March 2021 BAR Decision

BAR 21-03-07

506 Park Street, TMP 530123000 North Downtown ADC District

Owner: Presbyterian Church Ch'ville Trust Applicant: Karim Habbab, brw architects Project: Modify approved addition

Re: Trees

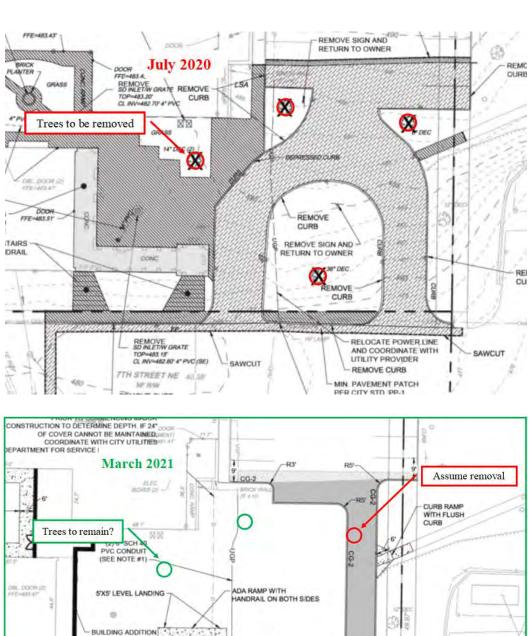
There are four trees within the work area that, for the July 2020 CoA, had been approved for removal. Three of the trees could now be retained. The BAR should clarify this.

ELEVATIONS - 7TH STREET AREA

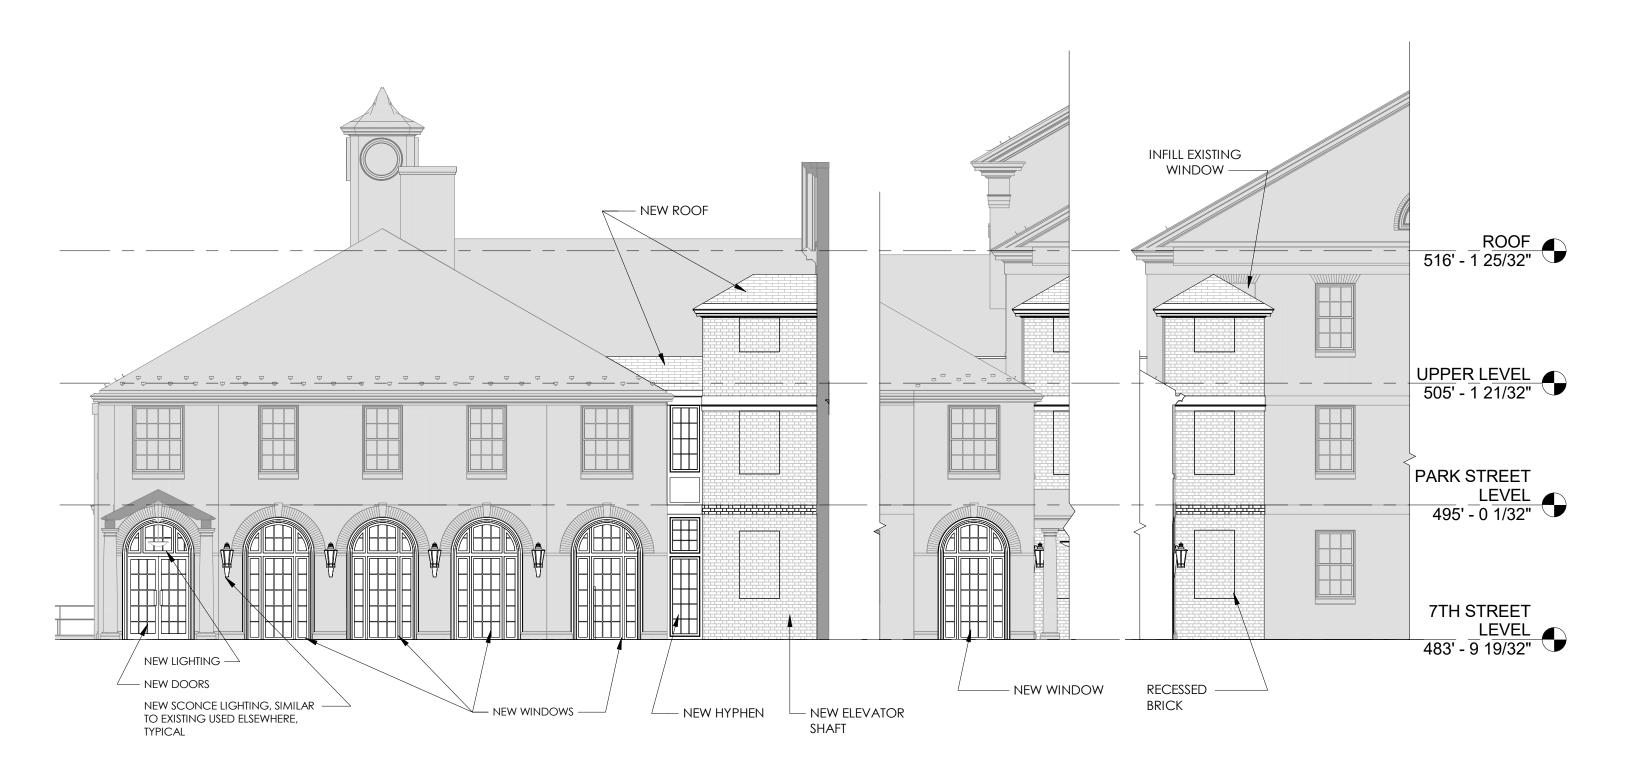
- that the height as shown of the elevator be reconsidered
- that the white banding around the elevator be reconsidered, and changes allowed if the designer decides to do so

At the elevator tower, the BAR should evaluate if the new brick panels should have sills similar to those on the adjacent, existing wall.

5. Sills at elevator tower panels. BAR may ask about matching the stone sills on the similar, existing panels. That would be fine to have a sill at the bottom of our recesses in the elevator shaft.

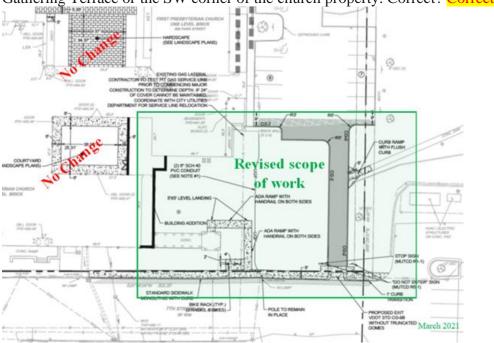
1. Scope of revised work limited to only the NE corner—green shaded area—and will not alter the previously approved landscaping and etc. at the Courtyard, Gathering Terrace or the SW corner of the church property. Correct? Correct!

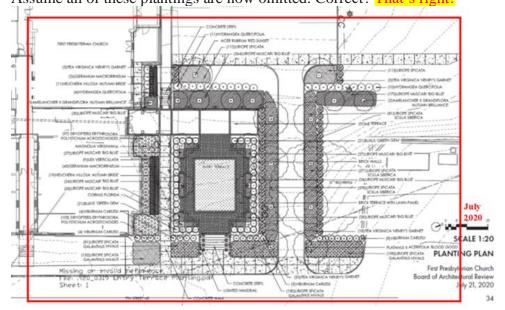
2. Assume all of these plantings are now omitted. Correct? That's right!

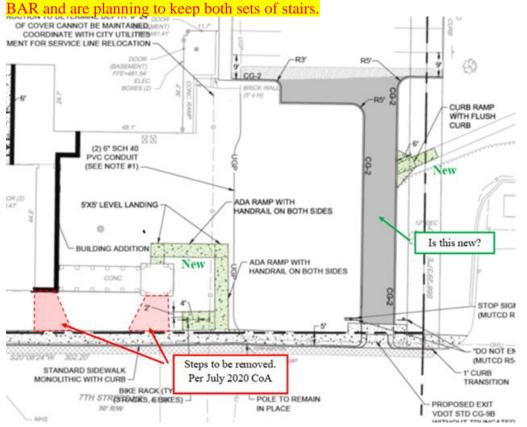
3. Excluding sidewalk work at street, I have a new ADA ramp, the sidewalk repair at the right, and the steps will be removed per prior CoA. What is the grey area—sidewalk or paving? Also, BAR may ask about railing at ramp. Assume it will match what was done at the new entrance approved in 2019. The grey area is a new drive. The new handicap ramp is at 8% so it requires handrails on both sides, painted black. At this point we did a minor revision to the plan submitted to

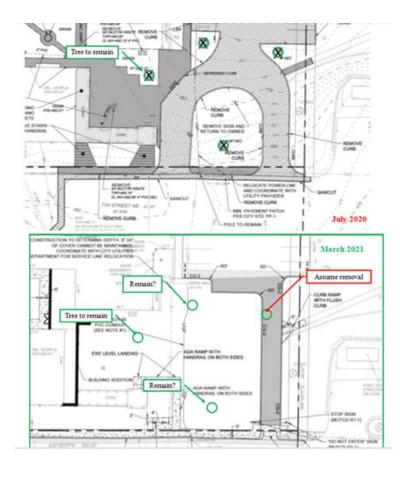
4. Trees. Originally, four trees would be removed. It appears three can remain, will they? The grading currently impacts all 4 trees and they're all shown to be removed. The City's detail to protect the tree critical root zone is not achievable for any of the trees. For example the large tree in between the existing entrance/exit lanes is 36" in diameter resulting in a 54' radius critical root zone. Also, BAR will ask if that tree will be replaced, with what, and where? I don't have an answer for this right now.
